SERVICE INSTRUCTIONS

No. 1117
ATA Code 24-50

SUBJECT: ELECTRICAL POWER - REPLACEMENT OF LOAD METER 15 AMP FUSES AND SPARES WITH 5 AMP FUSES AND SPARES

EFFECTIVITY: BEEHCRAFT Duchess 76, serials ME-183 through ME-237 and ME-239.

Figure 1.

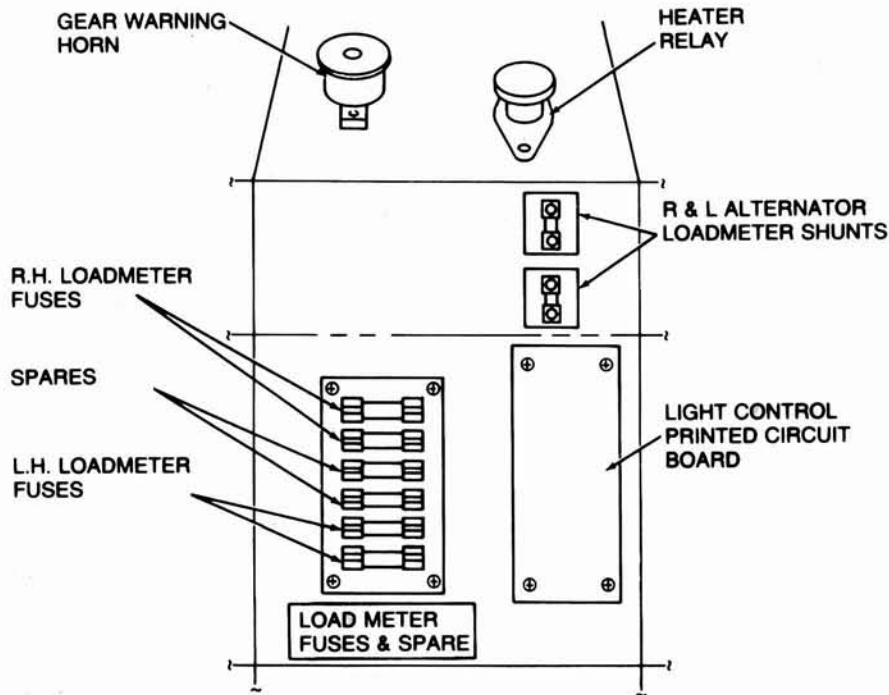
2. Remove and discard the P/N MDA15 load meter fuses and spares from the load meter panel located on the RH forward side of the lower center panel console. Reinstall the new P/N MDA5 fuses and spares as shown in figure 1.
